**Goddard Space Flight Center  
Wallops Flight Facility  
Wallops Island, VA 23337**

## Meeting Minutes

Shoreline Restoration and Infrastructure Protection Program EIS

| Title:  | 2002 - 1934 Bathymetry Comparison<br>Shoal A & B |

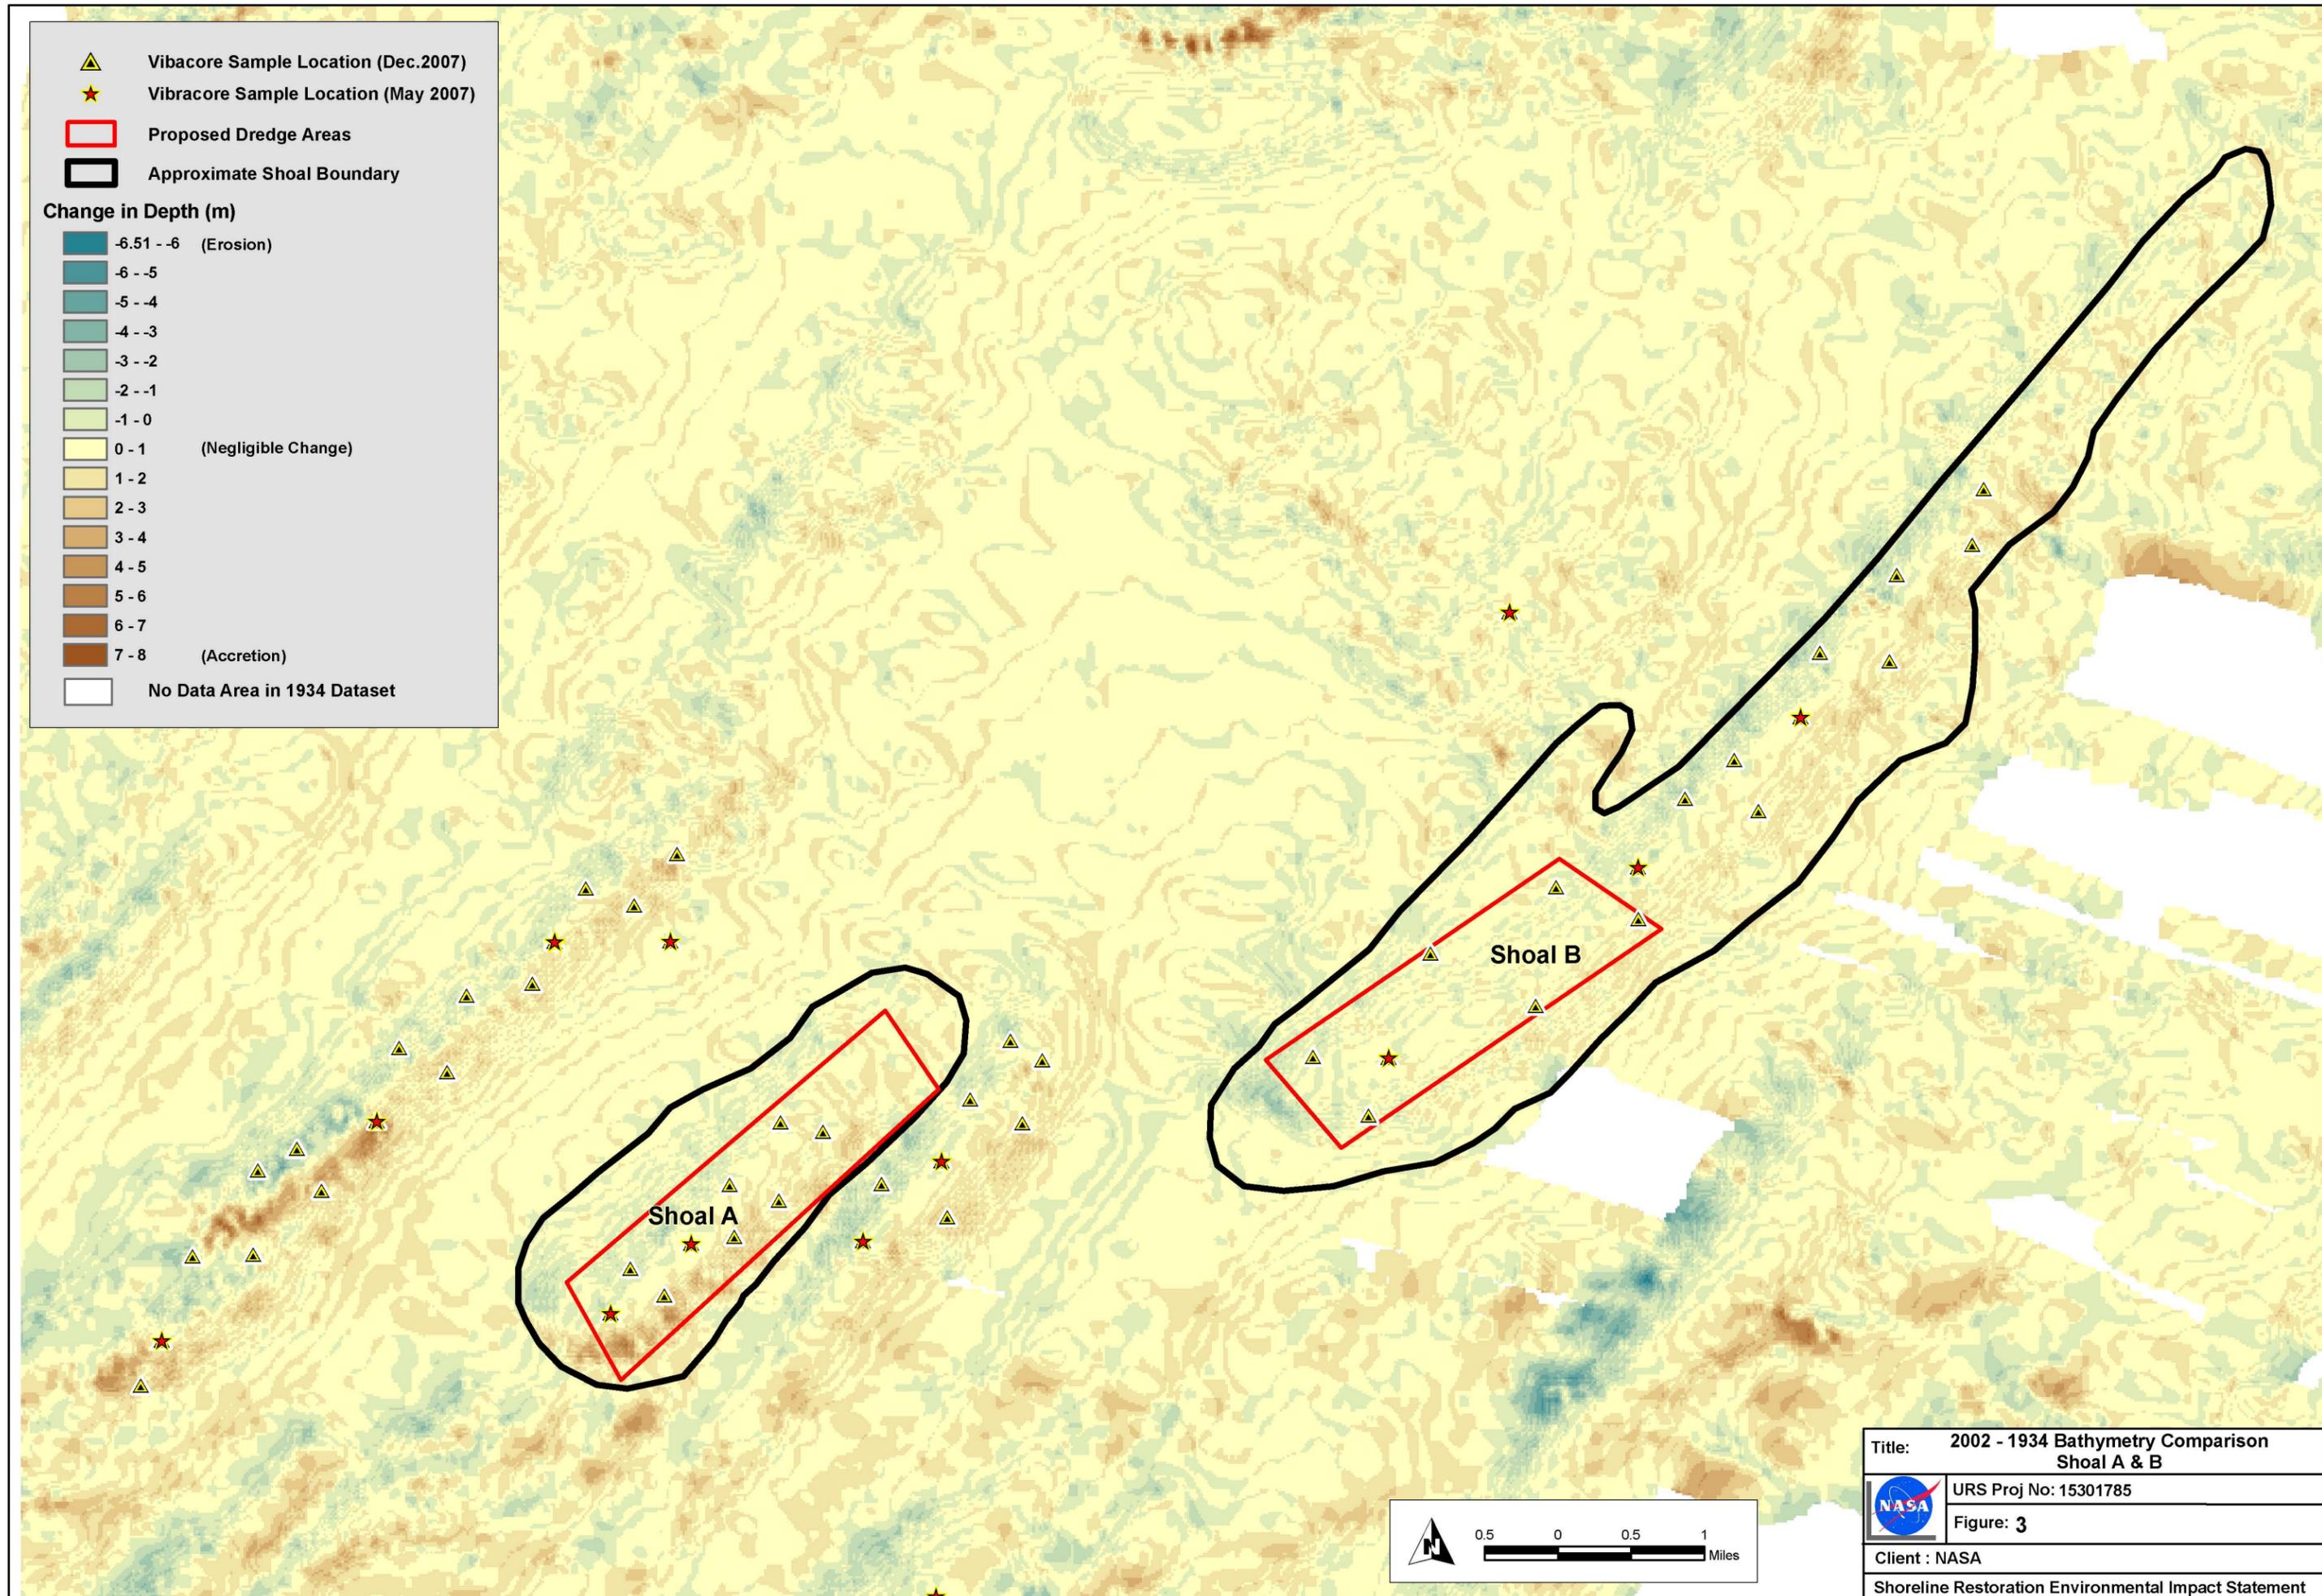
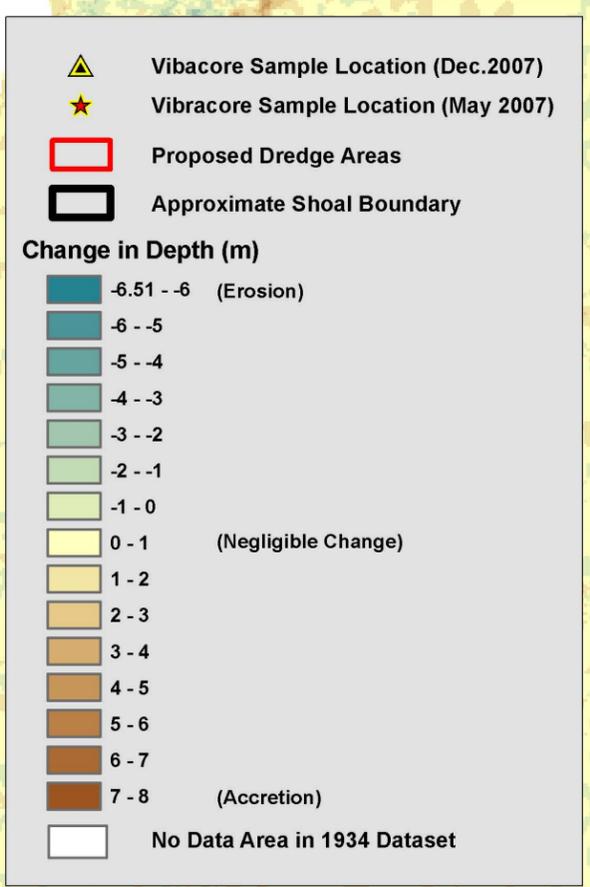
Response: We agree that targeting active accretional shoal features will likely minimize long term effects to geomorphology and habitat value. Figure 3 depicts the long term accretional and erosional areas of the shoals based on bathymetric changes from 1934 to 2002 (the most recent available) using bathymetric data from NOAA. As indicated on Figure 3, over the long term the southern and eastern portions of Shoal A are accreting. The southern part of the landward side of the shoal is shown as eroding over the long term. These patterns are consistent with the observations on Fenwick Shoal presented in USACE (2008, Figure 2-7, modified from Hayes and Nairn (2004)). We plan to avoid dredging the erosional area within the 2-square-mile study area shown on Figure 3 to the extent practicable. Since we are only targeting Shoal A for initial fill, we will evaluate the use of Shoal B for renourishment events in the future as needed.

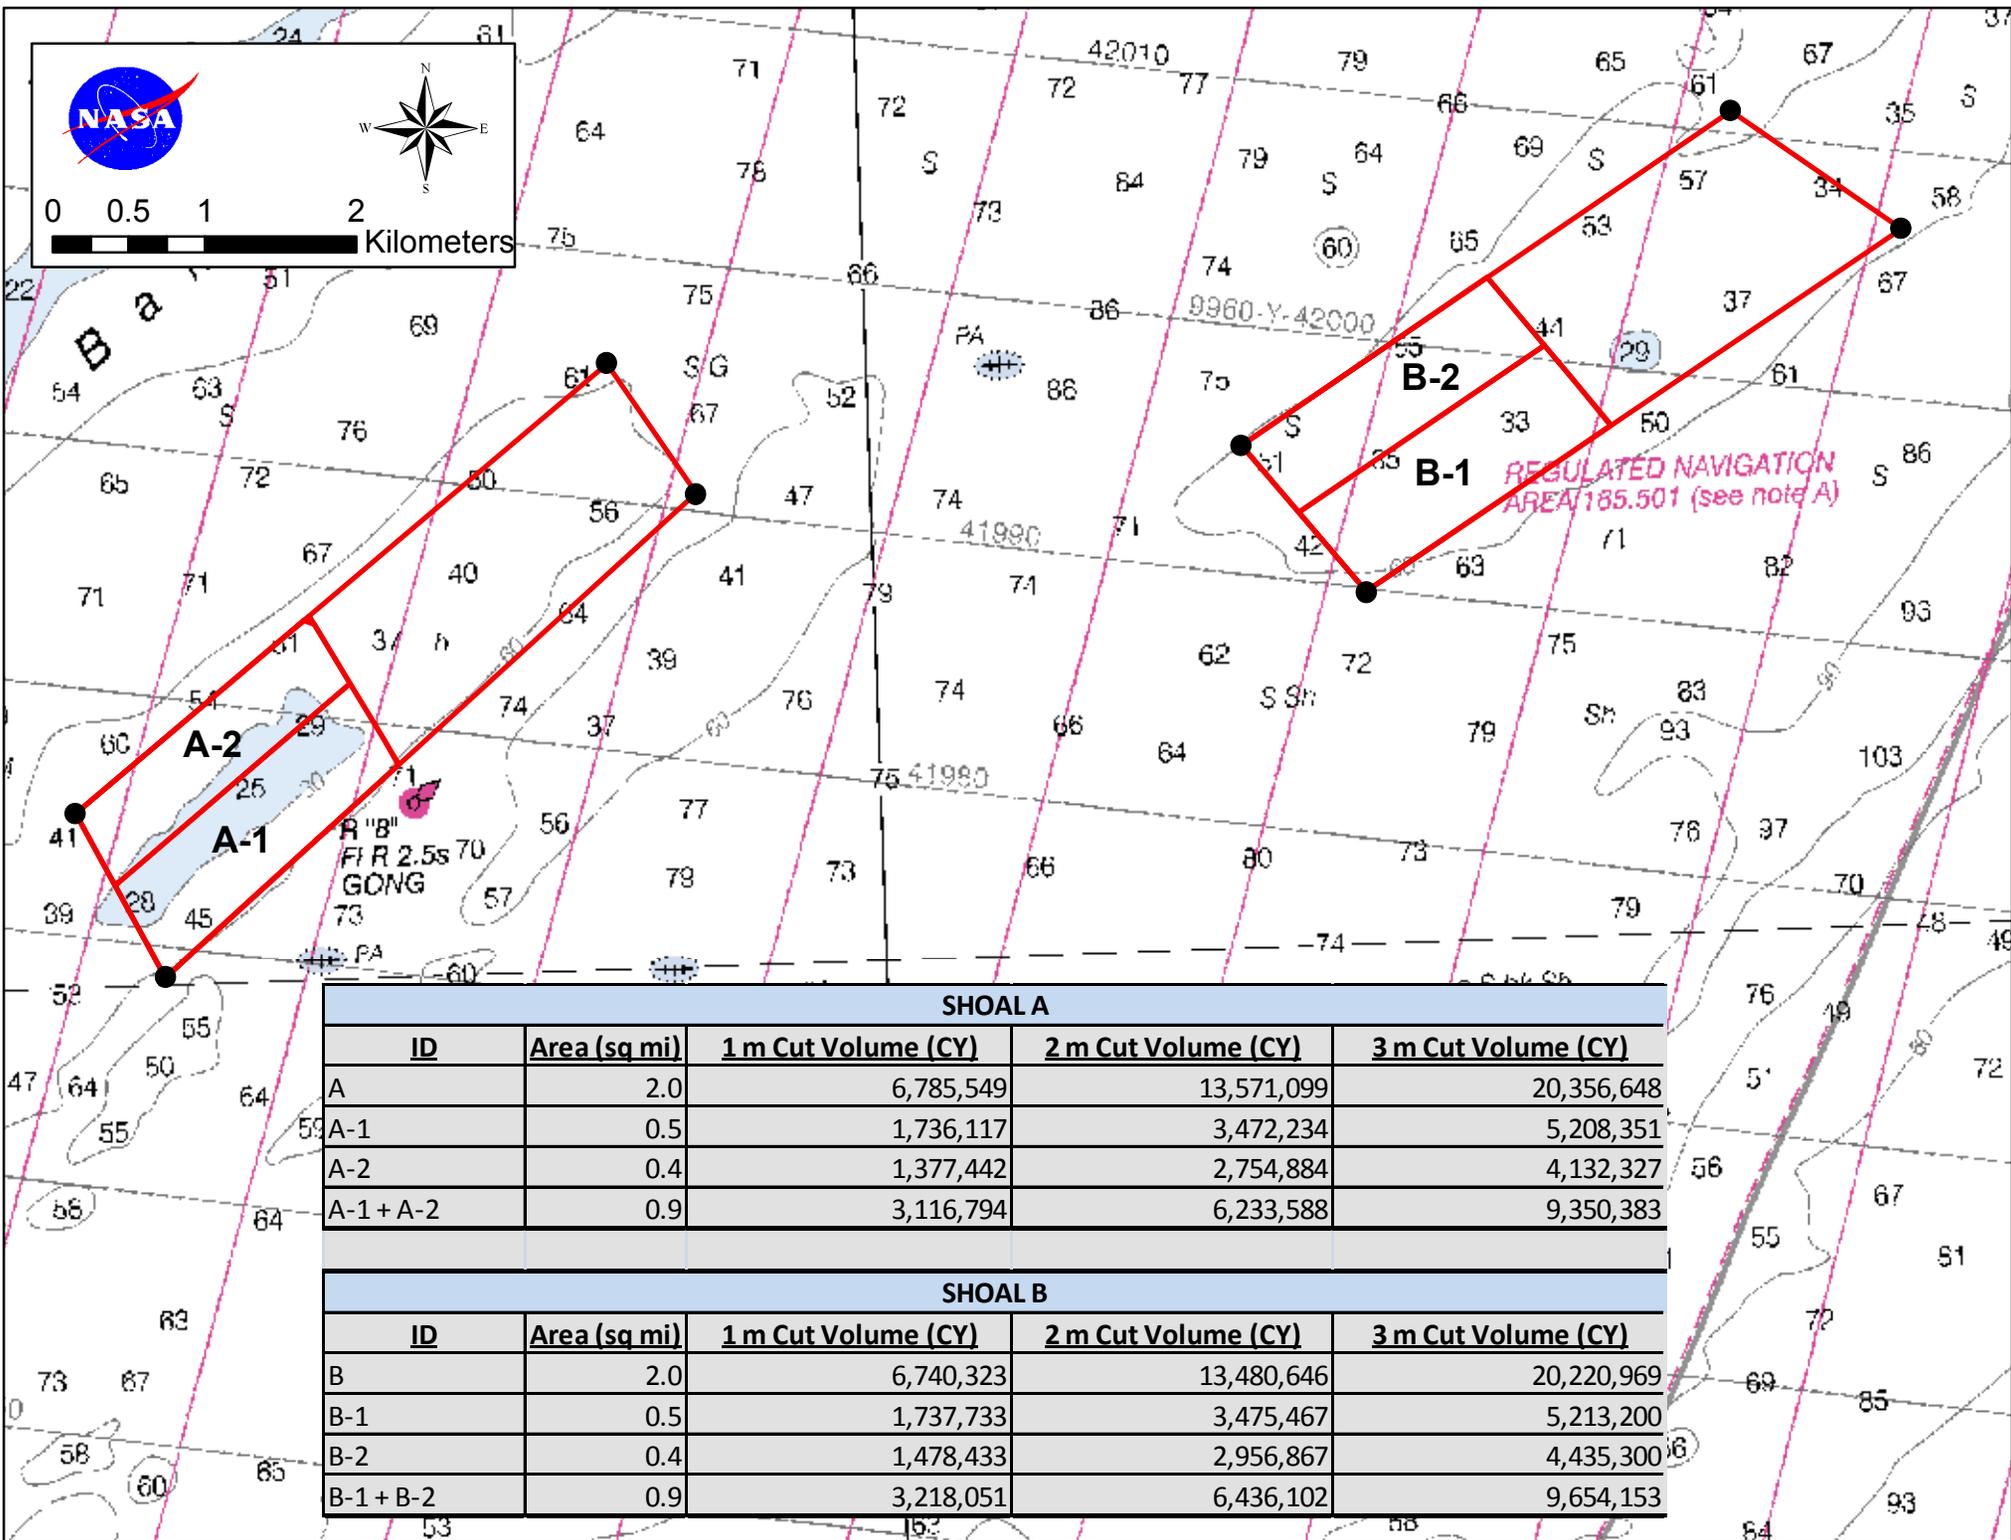
Attached is a map that I put together to depict what we talked about Monday. For initial construction of the project, it seems reasonable that we would target A-1 with a 2 m cut depth, and provided that we got what we needed, that's where we'd stay. We would only cut deeper within A-1 or go to A-2 only in an off-nominal case.
